# UNITED STATES PATENT AND TRADEMARK OFFICE

APPLICATION NO.	FILING DATE	FIRST NAMED INVENTOR	ATTORNEY DOCKET NO.	CONFIRMATION NO.
10/687,687	10/17/2003	Antonella Pesce	CM2525C	9352

<b>Office Action Summary</b>	Application No. 10/687,687	Applicant(s) PESCE ET AL. 	
	Examiner Michael G. Bogart	Art Unit 3761

**FIG. 3**

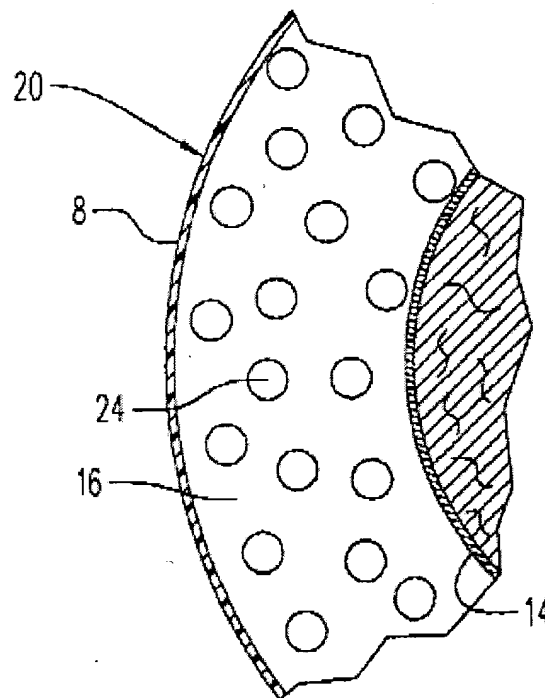
Regarding claim 14, Williams teaches that at least a portion of the wearer facing surface (16) comprises the agent (24)(fig. 3, below).
